The City of Spartanburg Board of Architectural Design & Historic Review

AGENDA

September 14, 2023, at 5:30 P.M.

RE: **COA: 23-040-00049: Certificate of Appropriateness for Major Works – 575 Cecil Court (TMS: 7-16-02-269.00) in the Hampton Heights Neighborhood Historic District. Applicant is seeking approval of a COA to install solar panels on the front roof. The property is located in the R-8 SFD (General Residential – SFD). Owner: Terry Anderson
Applicant: William Clementi.**

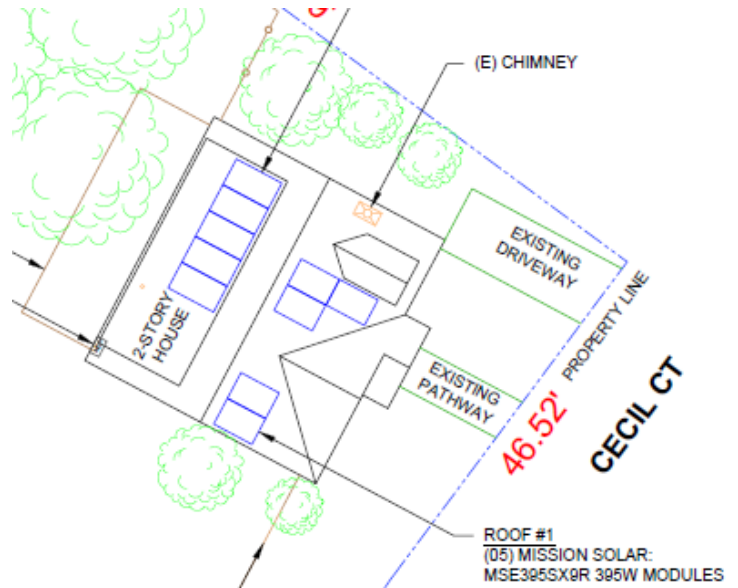
Each solar panel is about is **21.64sf** [3.5' x 6.3'] and laid flat upon the roof. The solar panels are attached by a railing system. The front panels will be split 2 / 3, where 2 panels to be installed left of the front gable door, and 3 to the right, between the entrance and window dormer.

The scale of the building would not be impacted the installation of solar panels. The drawings submitted by the contractor states that the solar panels will not raise higher than 6 inches.

Solar Panels are a modern utility and contrasts texture and materials typically associated with historic architecture. Installing solar panels requires several parts, including the rail system, mounting devices, and the 21.67 sf panels, comprised of 66 solar cells, and weighs just under 50 lbs.

ROOF PLAN WITH MODULES LAYOUT			
JOB NO.	DATE	DESIGNED BY:	SHEET
342624	7/19/2023	T.L.	PV-2A

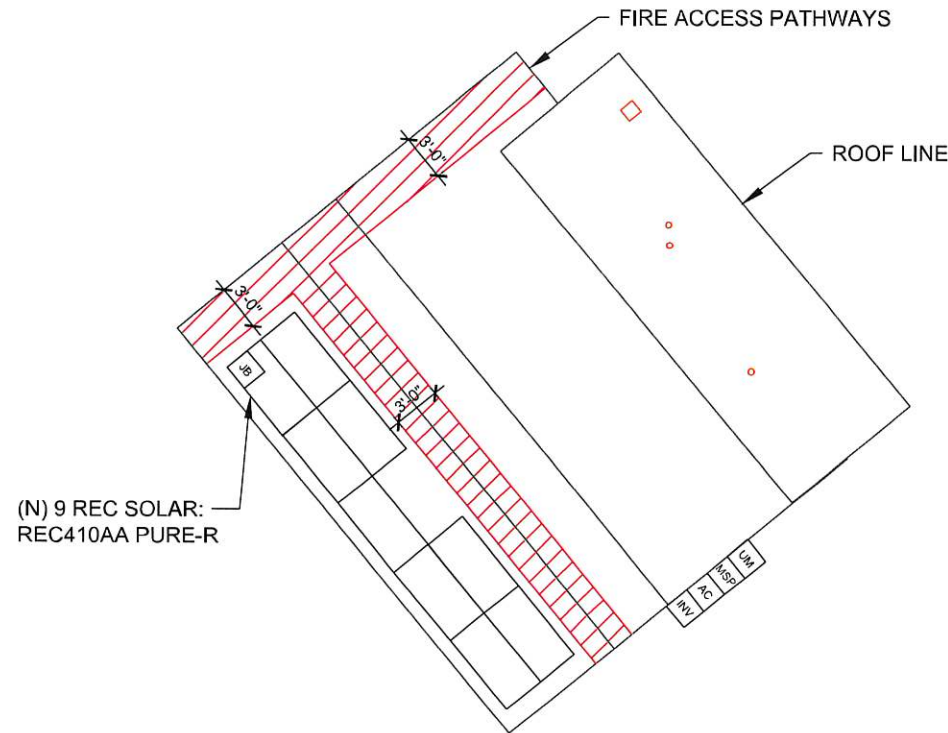
Despite the fact that currently in Beaumont Mill Village Historic District, there are no other houses having solar panels, adding solar panels will not drastically change the historic feature of the house and the historic neighborhood. Due to the low to medium profile of the solar panels, they would blend in with the District. Furthermore, as the photovoltaic industry continues to progress, it is likely that more homeowners will come to rely on solar panels in the near future.
